**NEW MEXICO  
ENVIRONMENT DEPARTMENT**

**RE: NOTICE OF DISAPPROVAL  
PARCEL 21 RCRA FACILITY INVESTIGATION  
WORK PLAN, FEBRUARY 7, 2008  
FORT WINGATE DEPOT ACTIVITY, MCKINLEY  
COUNTY, NEW MEXICO  
EPA ID# NM6213820974  
FWDA-06-003**

**Figure 4-2  
Proposed Sample Locations  
SWMU 2 - Building 515  
Fort Wingate Depot Activity  
McKinley County, New Mexico**

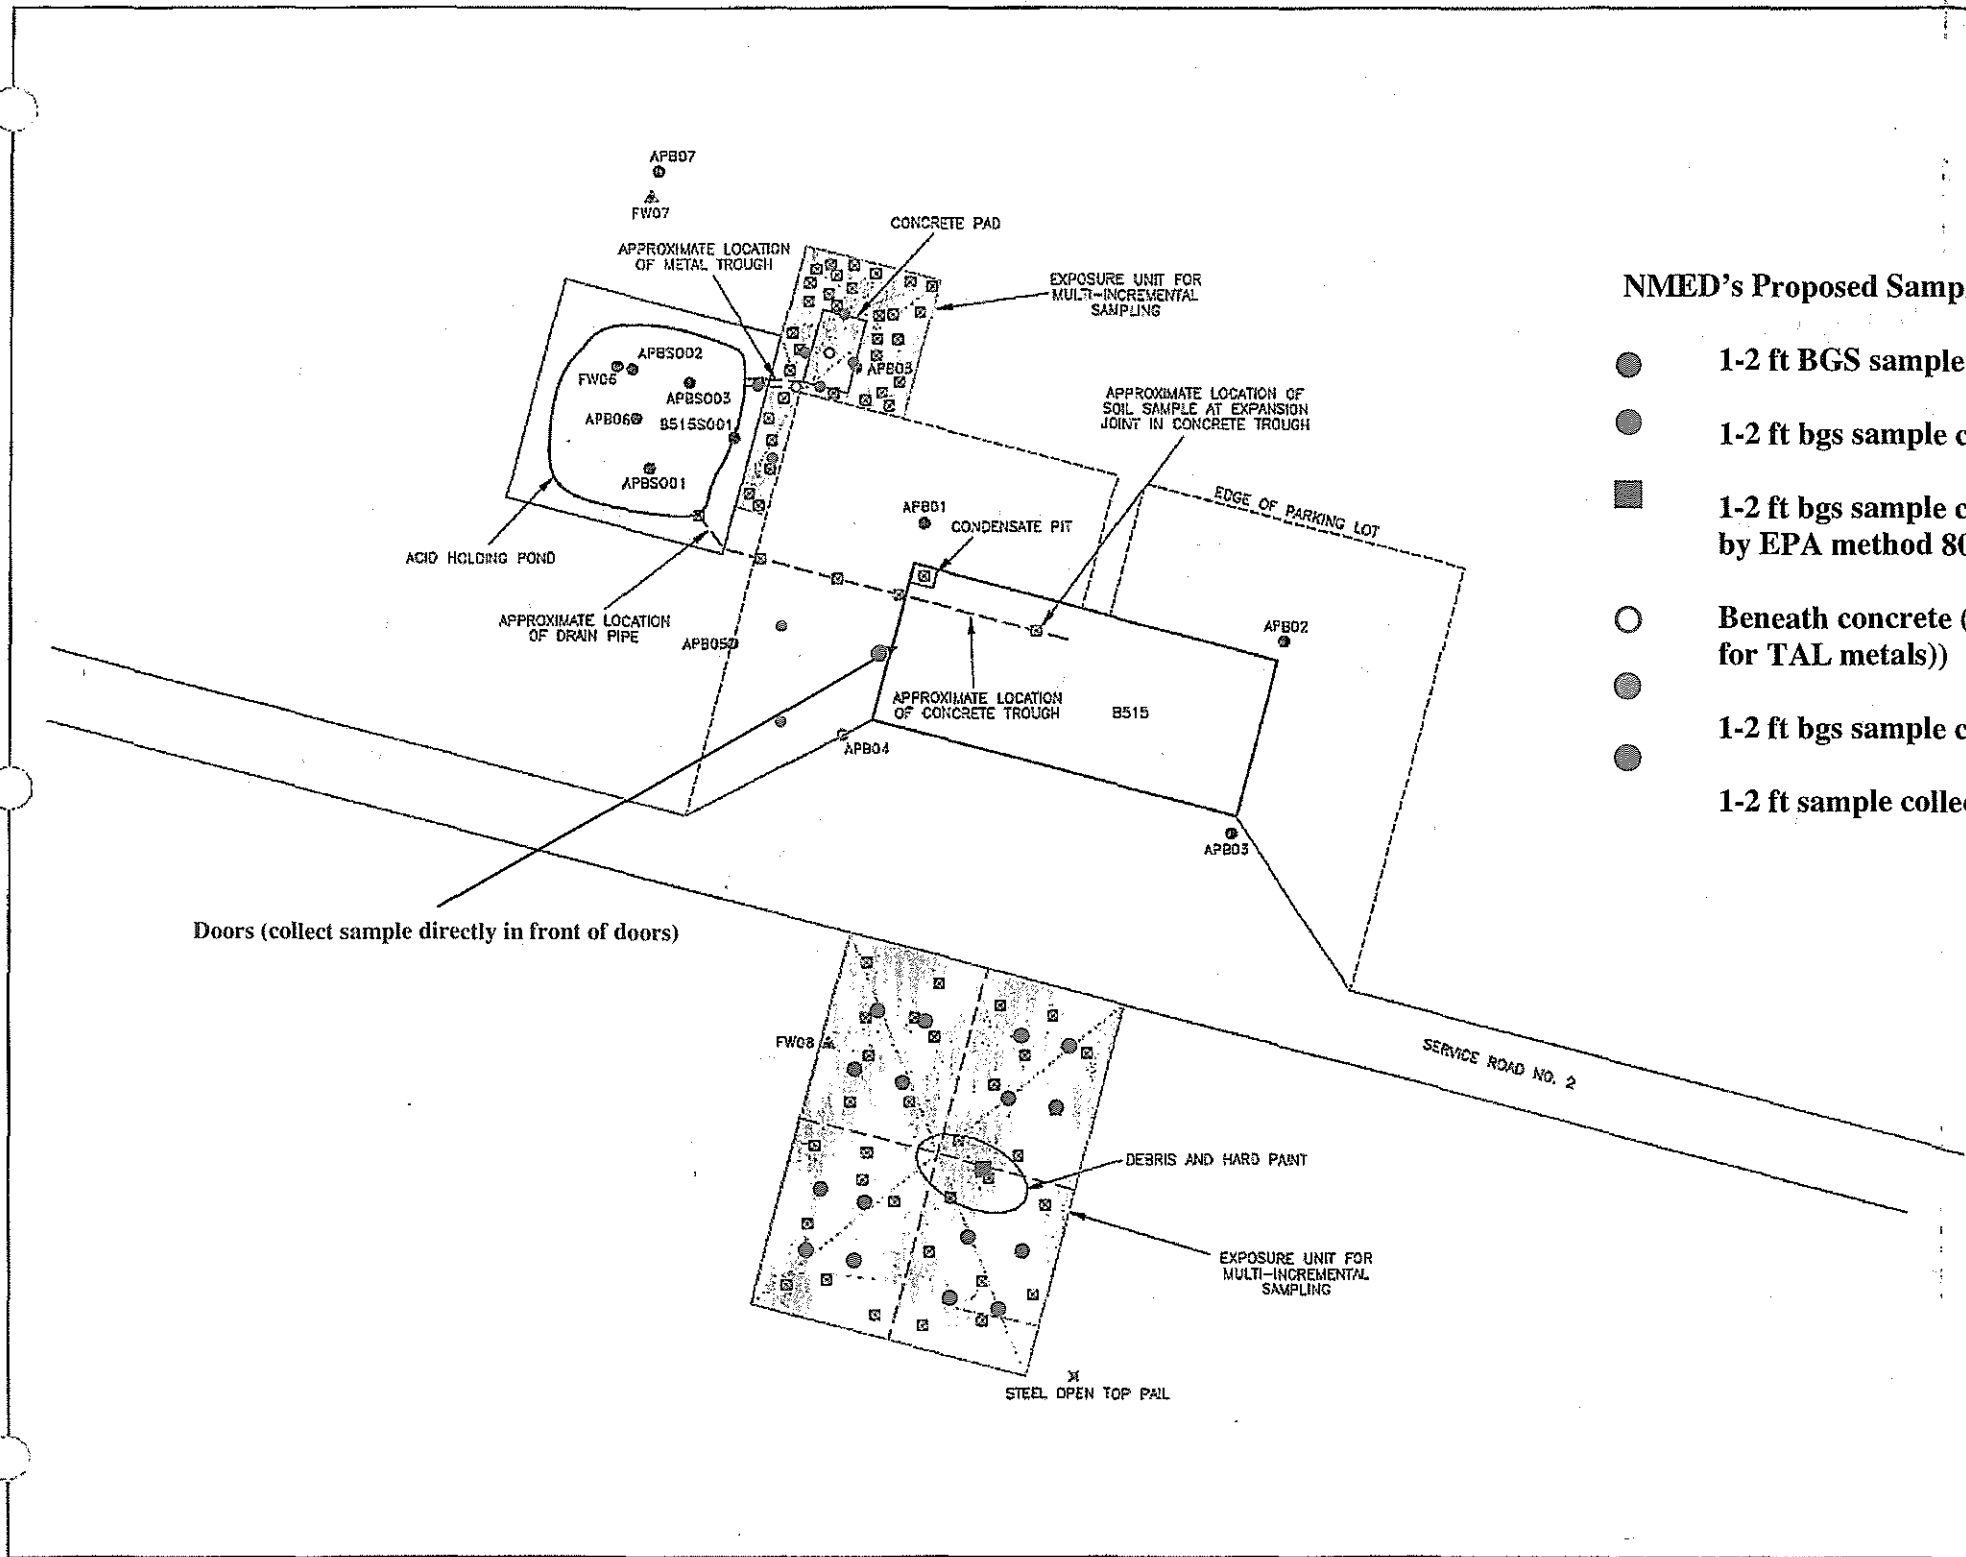
In Section 4.4.1 (Soil Characterization) the Permittee proposes to collect MI soil samples from the paint debris disposal area, and from the concrete pad area and associated metal drain trough. In the response to Comment 15 of the NOD, the Permittee states that the "[U]nited States Environmental Protection Agency (USEPA) has referenced MI sampling in its latest revision of the analytical method for the trace analysis of explosives and propellant residues." Explosives and/or propellant are not likely constituents of concern at the paint debris disposal area (see Comment 2) and therefore MI sampling does not apply. The Permittee must therefore collect discrete soil samples from the areas mentioned above. NMED's suggested sample collection locations are shown in the attached Figure 4-2.

In the response to NOD Comment 36, the Permittee states that soil samples were collected from areas downgradient of the two double doors located on the west side of the building (i.e., the four corners of Building 515). Samples collected from the corners of the building are not representative samples for potential spills that may have been related to loading/unloading activities. During a previous site visit, NMED observed that the asphalt located near the doorway was damaged. Therefore, it is likely that if any spills occurred, the underlying soil may have been affected. The Permittee must collect one soil from the native soil just below the subgrade (at the location marked in the attached Figure 4-2).

**NMED's Proposed Sample Locations**

- 1-2 ft BGS sample collection depth (analyze for GRO, DRO, Pb, VOCs)
- 1-2 ft bgs sample collection depth (analyze for VOCs)
- 1-2 ft bgs sample collection depth (analyze. TAL metals, VOCs, GRO, DRO, PCBs by EPA method 8082)
- Beneath concrete (collect sample at the interface between subgrade and soil) (analyze for TAL metals))
- 1-2 ft bgs sample collection depth (analyze for Pb, GRO, DRO)
- 1-2 ft sample collection depth (analyze for GRO, DRO, TAL metals)
